Subject: Camden ref 2014-7043-P 44-44A Gloucester Avenue COU to residential units

2014/7043/P
44-44A Gloucester Avenue London NW1 8JD
Change of use from office use (Class B1) to provide 1x1 bed & 17x2 bed residential units Victoria Square Property Company Ltd
528311 / 184016

44-44A GLOUCESTER RD Network Rail Land And Assets

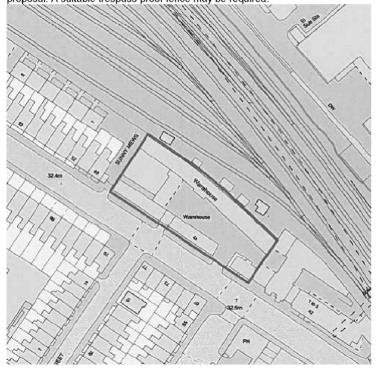
Network Rail is concerned that we have not been directly notified of this proposal either as a consultee or as a neighbour despite this proposal being adjacent to the operational railway. I have attached a plan showing Network Rail land and assets:

Green = operational railway Yellow with blue boundary = light maintenance depot Brown = right of access 'L' symbol = listed building

- 1. The proposal is to convert offices to residential units. The proposal is adjacent to the Camden Washer (Primrose Hill) light maintenance depot. The council and the developer are advised that the proposal should not impact Network Rail from undertaking its statutory obligation. Future residents, the developer and the council should be advised that works on site at the light maintenance depot can operate around the clock (24/7, 365) including works at night, weekends, during bank holidays. Any proposal at this site would need to provide suitable noise, vibration, lighting and dust mitigation for any works on site and potential residents would need to be advised that their dwelling may be impacted from noise, light, dust and vibration from the light maintenance depot as well as the adjacent operational railway. Network Rail will not accept any liability for disturbance from noise, vibration, dust or lighting etc for the site as the developer should already be aware that they are proposing to build next to an existing working railway site. Network Rail would request that the developer undertakes an environmental assessment including assessment of current background dust, air quality, noise, vibration and lighting and that mitigation measures are put in place by the developer to ensure that there is suitable protection on site for residents and that Network Rail can continue its operational undertaking.

- 2. There is a right of access in close proximity to the site and this access to the operational railway must remain open and unblocked around the clock (24/7, 365) both during construction works on site and as a permanent arrangement for Network Rail maintenance teams and emergency vehicles. In instances where there are issues relating to the access the developer must contact the Network Rail Operational Property team:

3. The attached plan shows that there is a listed structure in very close proximity to the proposal – in this case the listed railway vaults (formerly Camden Incline Winding Engine House). The developer must ensure emergency access / supply of the winding engine vaults is maintained both during construction works and as a permanent arrangement. To discuss this issue the developer must contact, in the first instance, the Network Rail Asset Protection Team:
